REQUEST FOR ADDITIONAL INFORMATION  
**ADAMSTOWN BOULEVARD**  
**PHASE 1**

MCCAULEY DAYE O'CONNELL ARCHITECTS

QUINTAIN

Planning Ref: SDZ22A/0007  
Application Date: 06-05-2022

### 3.3 RFI 3.C H4HAF - AS SUBMITTED

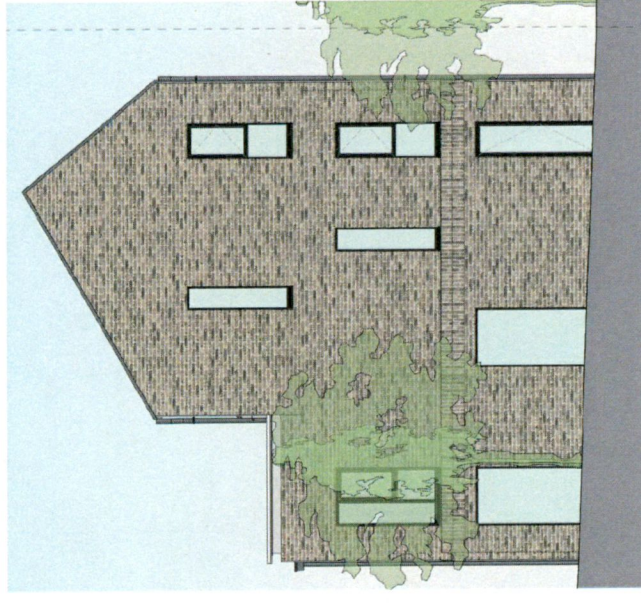
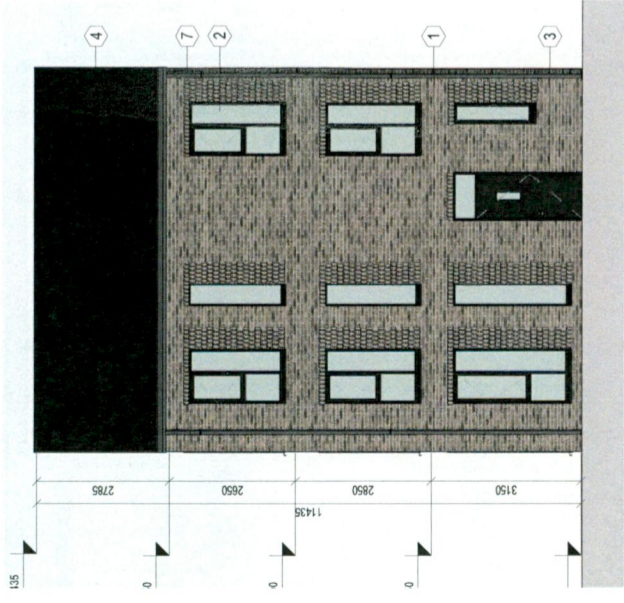
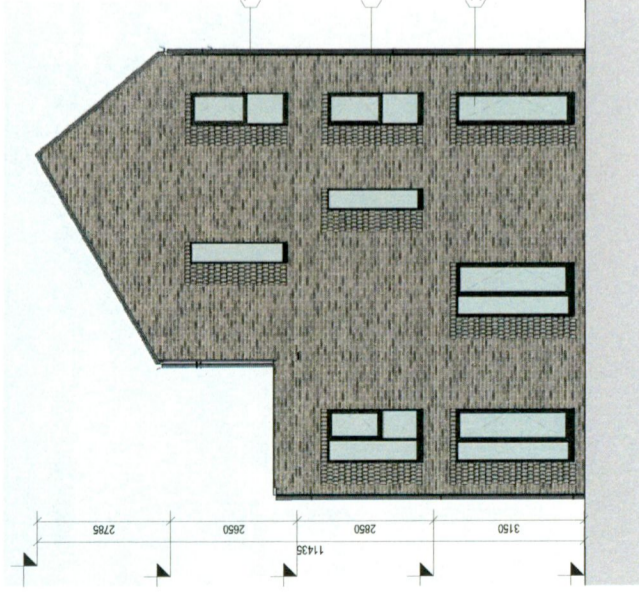
SDCC have requested further details of each landmark to demonstrate their significant design quality and discernibility from adjacent buildings.

- In order to further emphasise the landmark features, we have;
- added brick detailing to all windows to exposed gables
  - maintained the increased height of the building to help contrast with adjacent building

## H4BCF3 - AS SUBMITTED

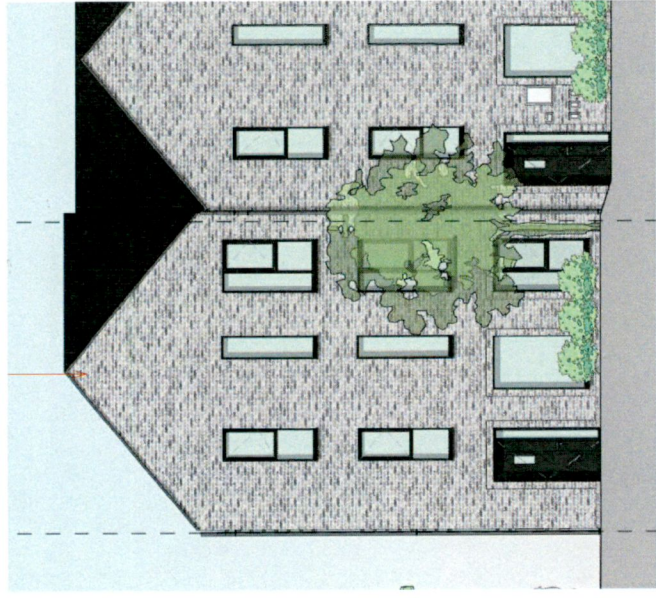
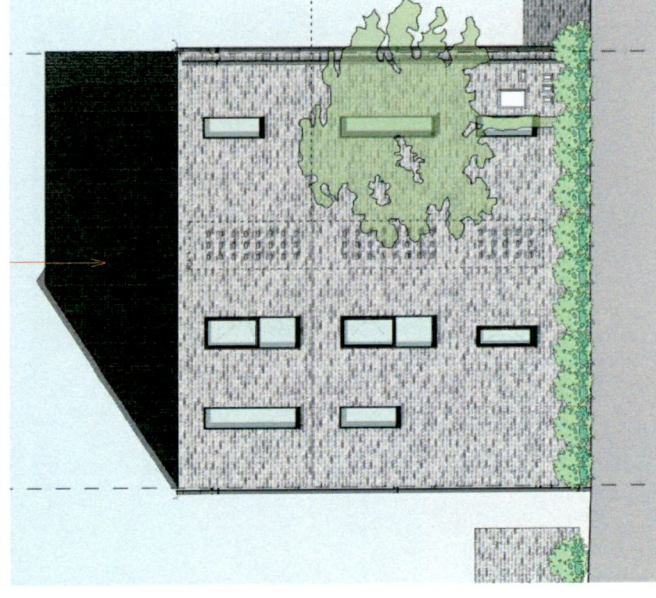
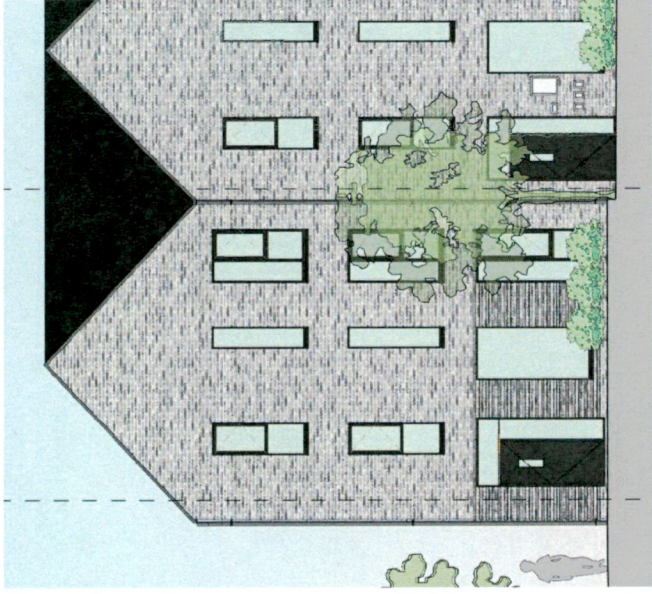
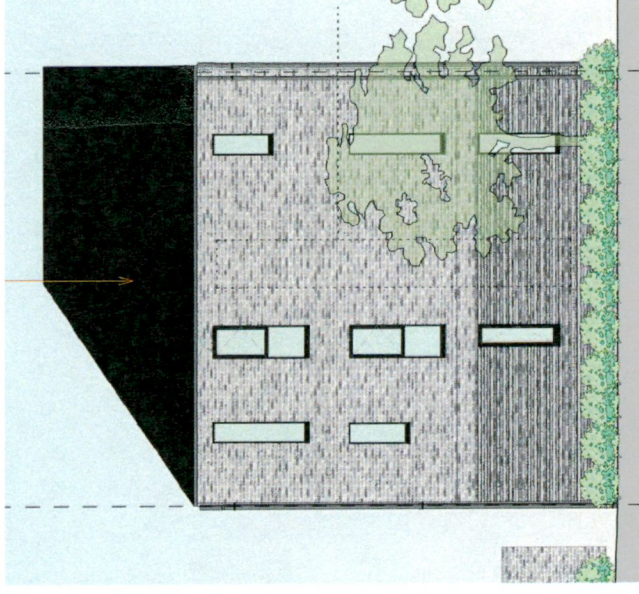
SDCC have requested further details of each landmark to demonstrate their significant design quality and discernibility from adjacent buildings.

- In order to further emphasise the landmark features, we have;
- the entire terrace of 5 units is treated as a landmark
  - alternative brick detailing extent to exposed gables that turn the corner
  - increased the height of the building by increasing the ground floor to ceiling height including windows and door.
  - proposed alternative brick colour to clearly differentiate from the adjacent buildings.
  - varied the roof profile from the neighbouring terrace to ensure this terrace is discernible from the others along the Linear Park.
